1988 - 1990 Corvette: Service Bulletin: Power Steering Shudder / Groan

Subject: POWER STEERING SHUDDER/GROAN INSTALL P/S COOLER & HOSE

Model and Year: 1988-90 CORVETTE WITH 5.7L ENGINE

Bulletin Number: 90-376-3B - (10/25/1990)

Step B Illustration

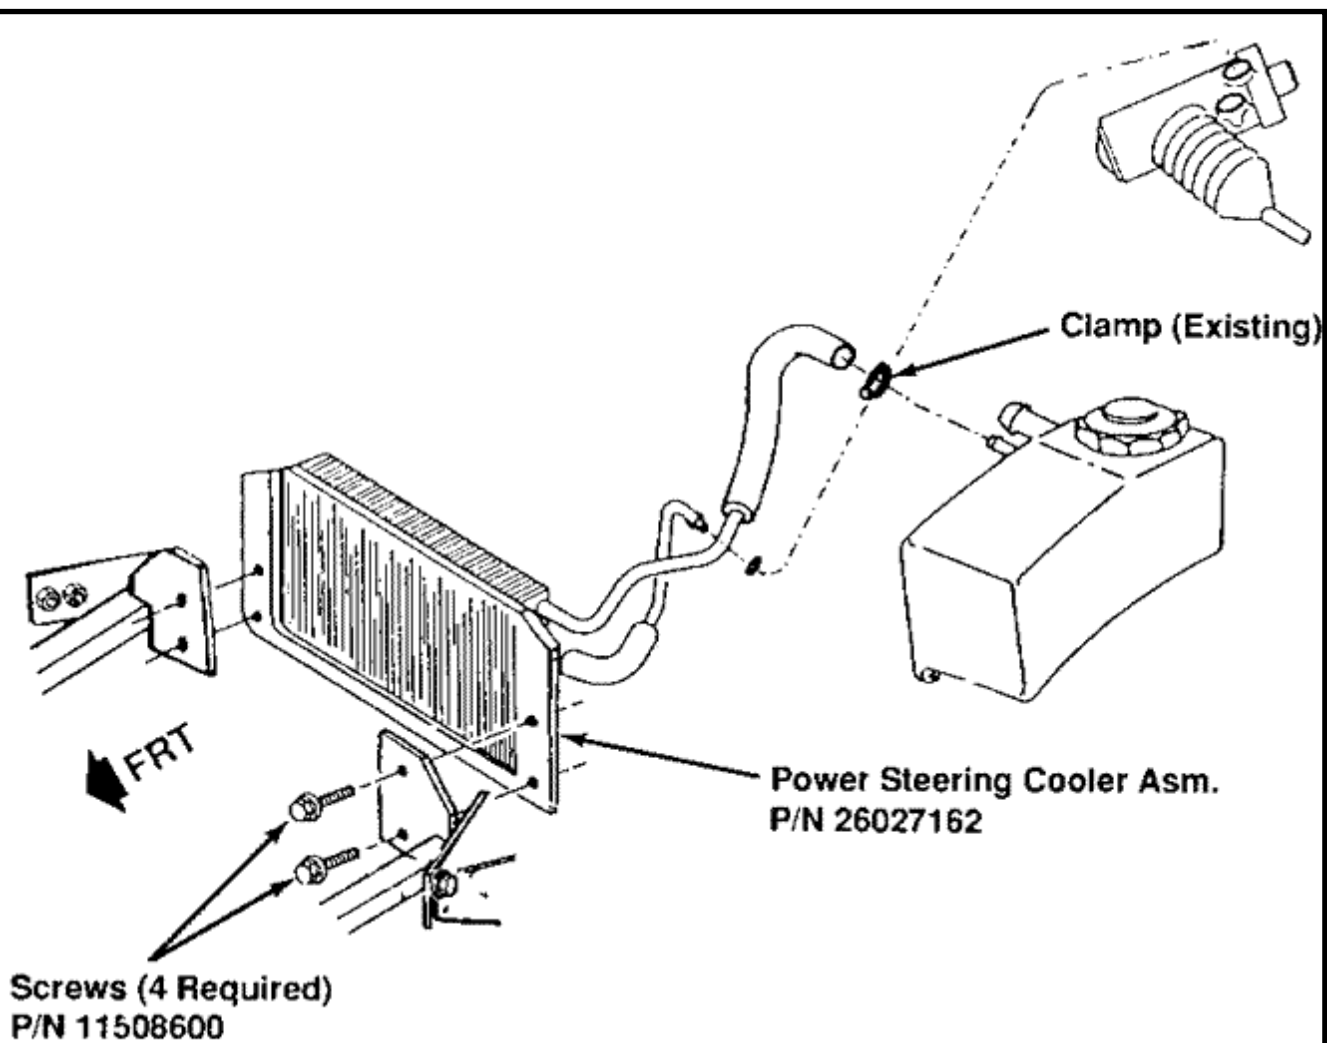
Replace existing pressure/inlet hose (pump to steering gear) with new assembly with internal tuner cable.

Power Steering
Pressure/Inlet Hose Asm.
P/N 262027177

Pipe at Pump End of
Hose Asm. is to be
Against Lower Corner
of Pump

Torque Specifications
Fittings (Pressure/Inlet Hose) – 28 N·m (21 lbs. ft.)

Step C Illustration (1990 Vehicles)

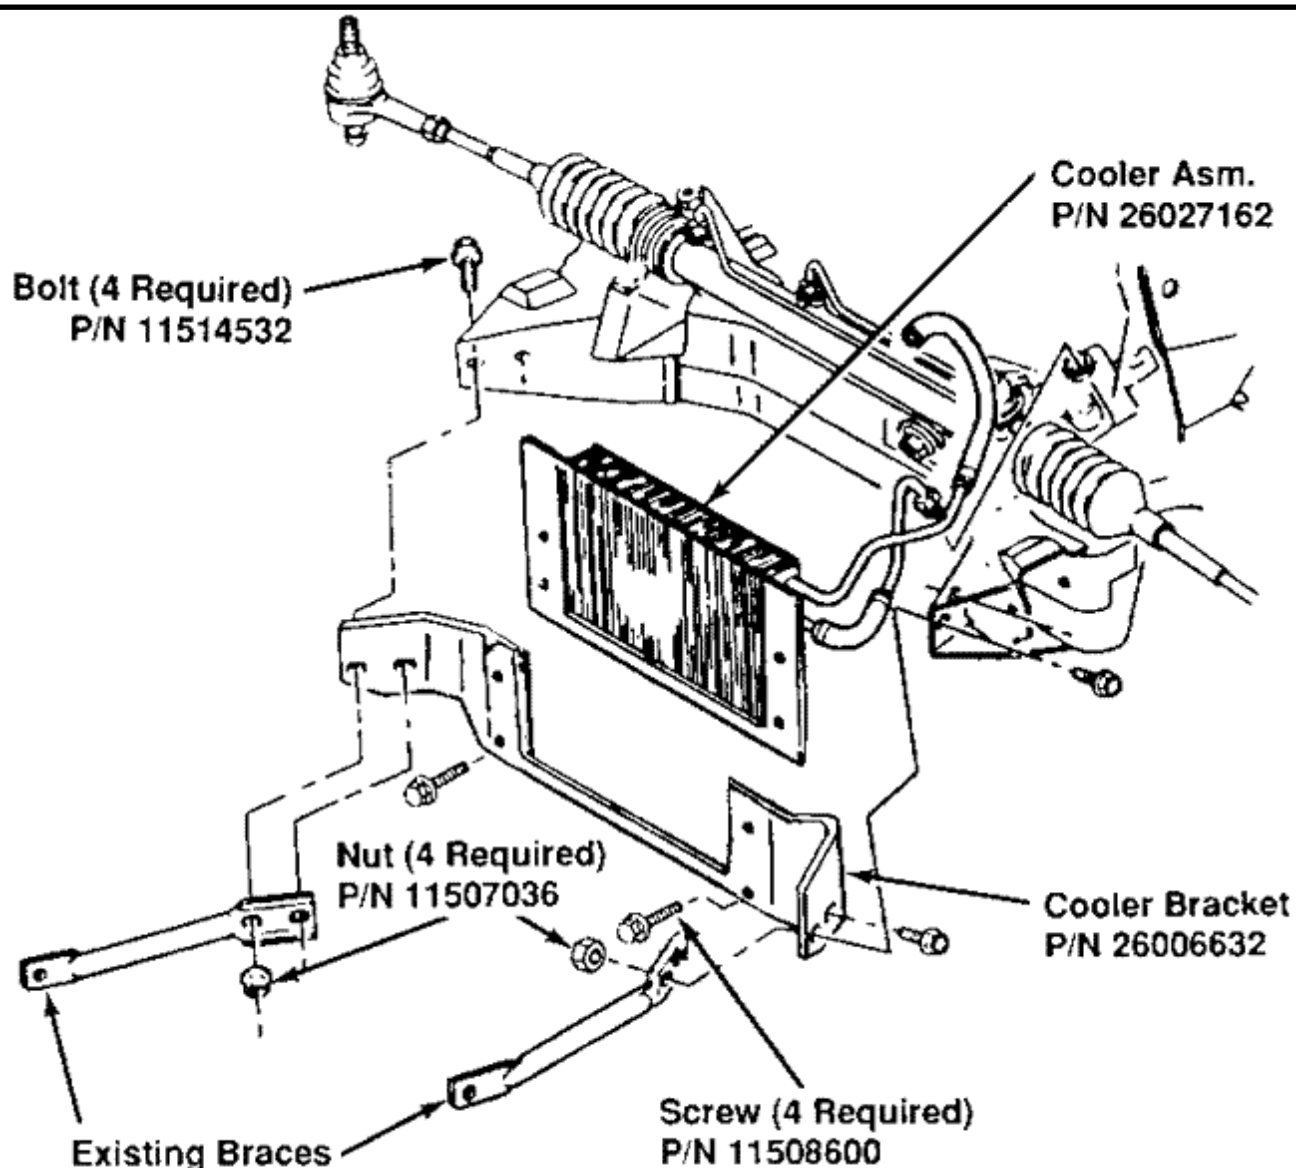
Replace existing power steering loop/pipe cooler with finned cooler that includes return hose with tuner cable.

Torque Specifications

Fitting (Return/Outlet Hose) – 28 N•m (21 lbs. ft.)

Clamp (Reservoir Hose) – 2.5 N•m (22 lbs. in.)

Screws (Cooler/Bracket) – 10 N•m (89 lbs. in.)
